CITY OF TORRANCE, CALIFORNIA

ADDENDUM NO. 1

**LANDSCAPE MAINTENANCE SERVICES FOR
STORMWATER BASIN ENHANCEMENT PROJECT
RFP No. B2015-23**

**ENTRADERO BASIN
SITE MAP**

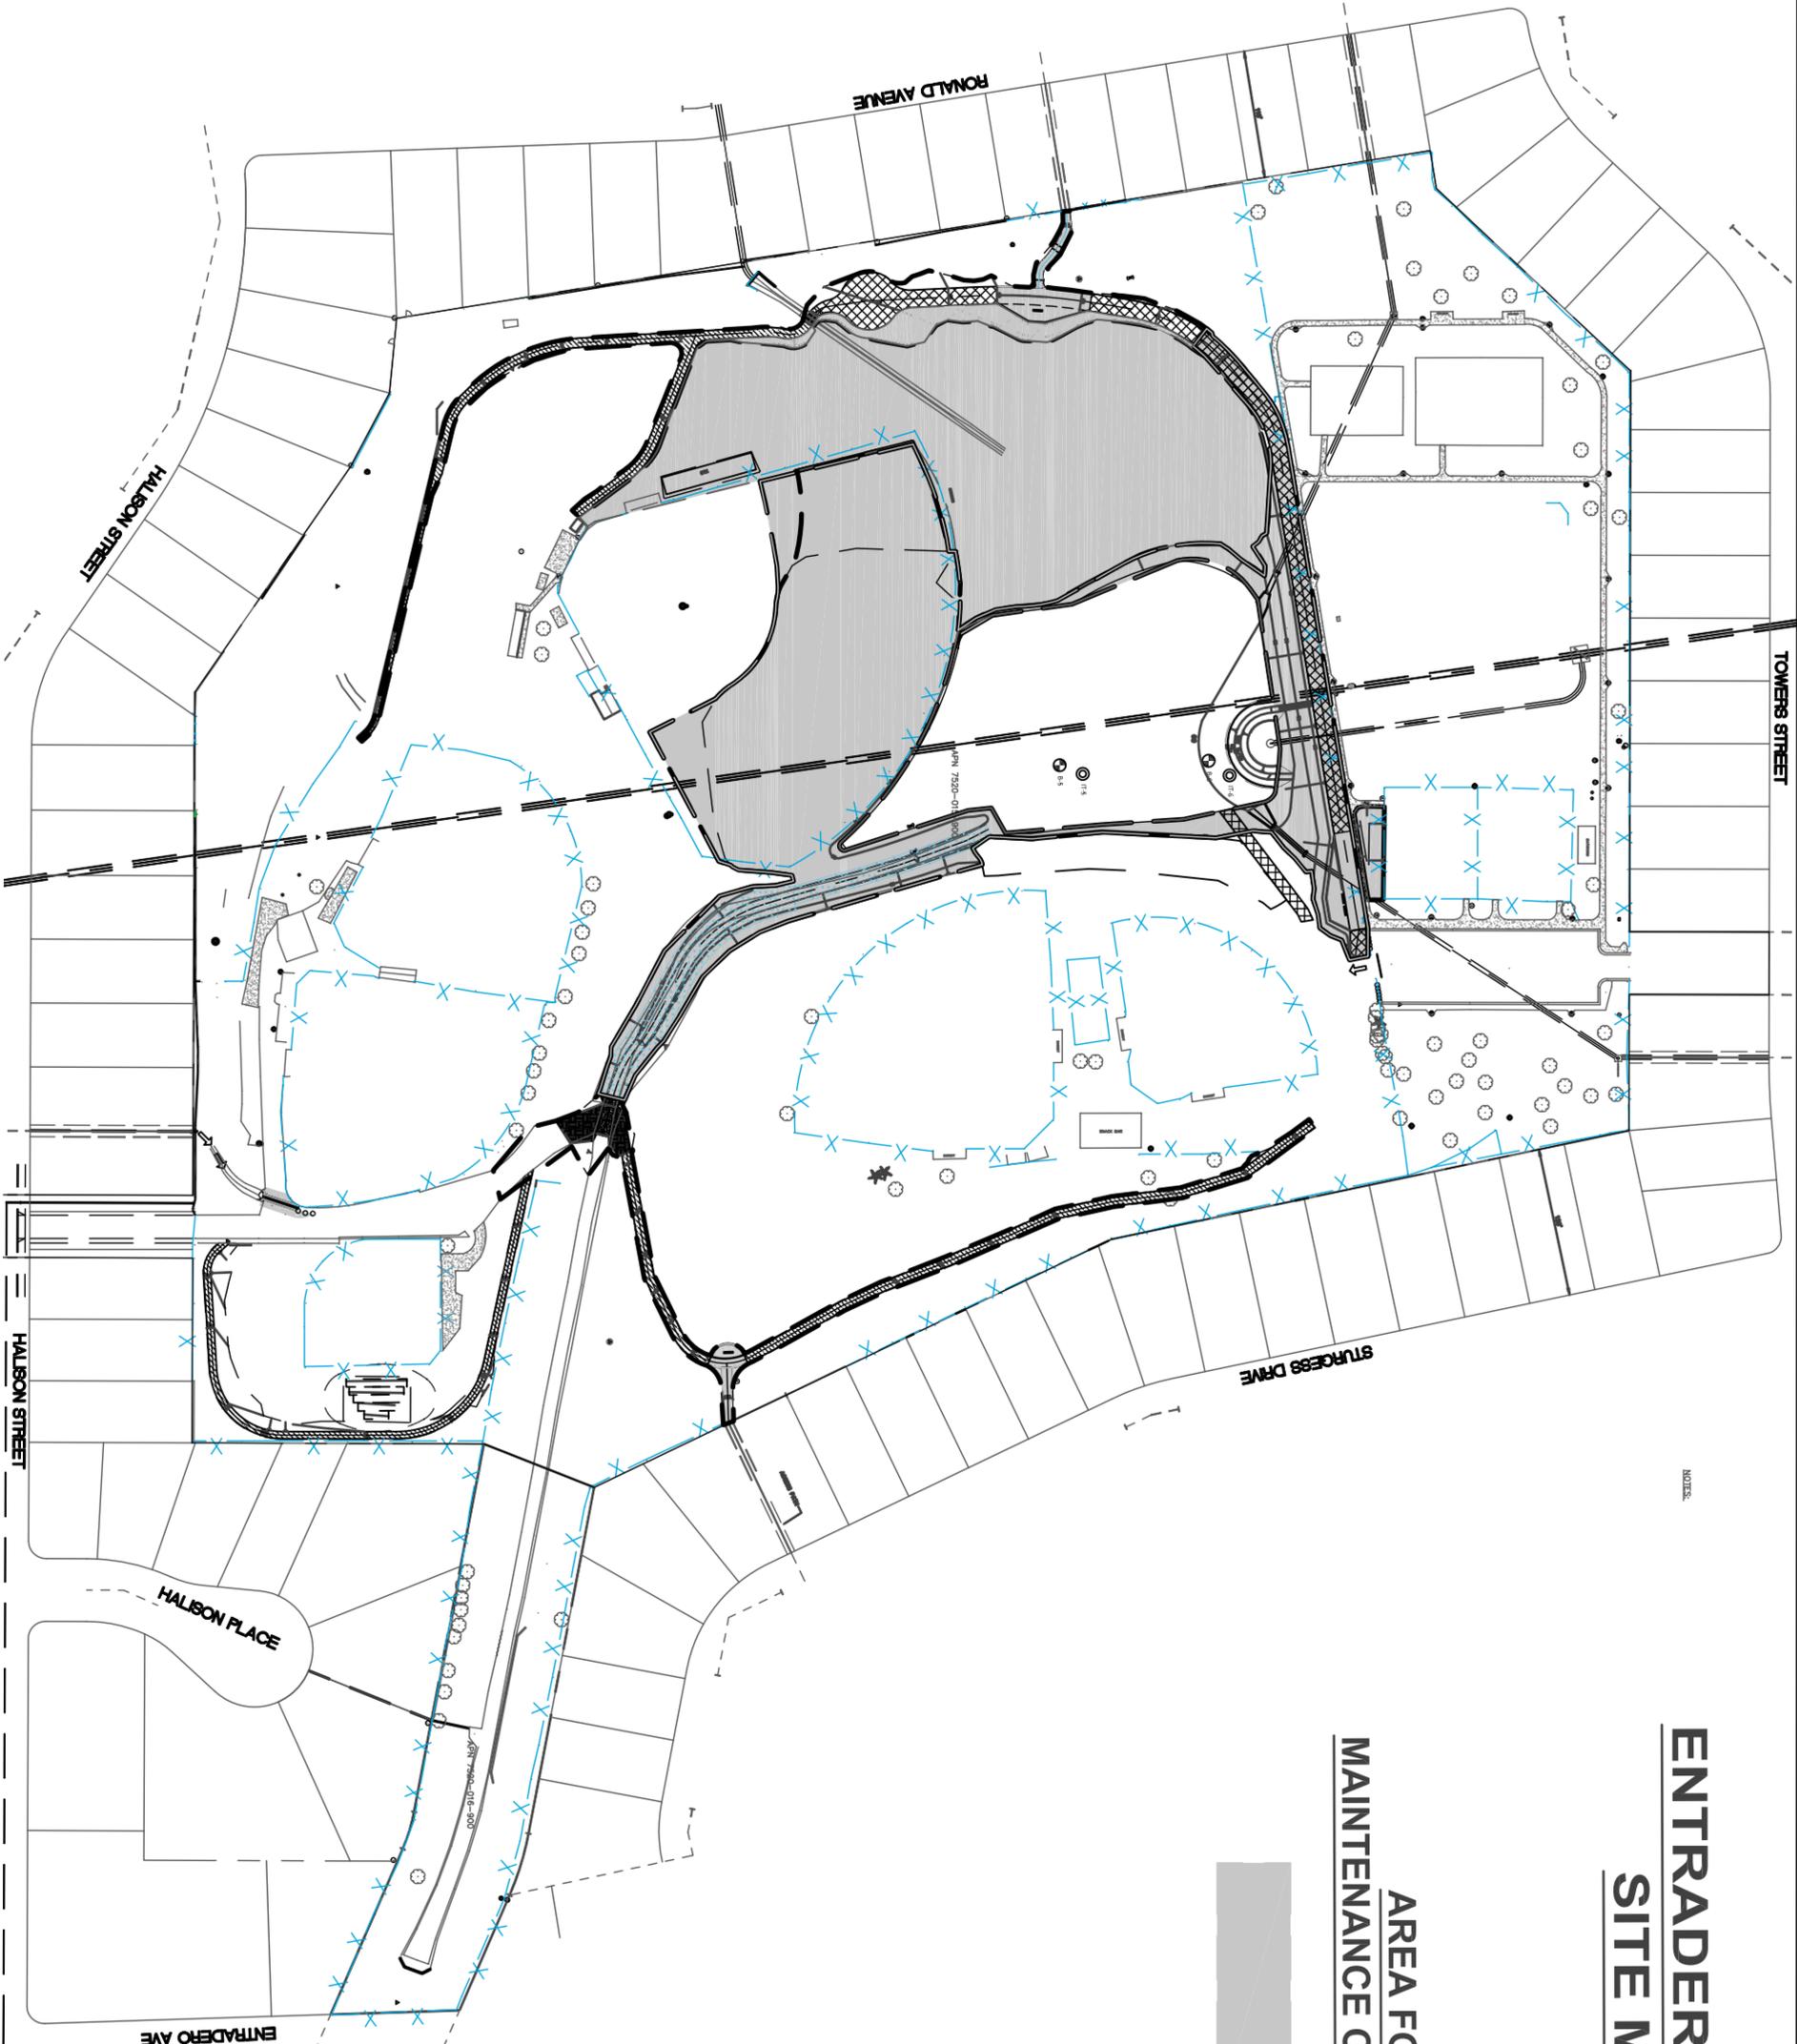
- d. The irrigation areas for the Entradero Basin/Park are further delineated on the ENTRADERO BASIN SITE MAP attached to this addendum. Irrigation lines for trees and the trees planted outside the areas delineated in the map are included in the Scope of Work and shown on sheets L-19, L-23, L-27 and L-31 of the Stormwater Basin Enhancement Project plans. Plans can be viewed at <http://www.torranceca.gov/15435.htm> The maintenance of the large baseball field outfield is also included in the Scope of Work. The baseball field outfield must be mowed 45 times per year and fertilized twice yearly.
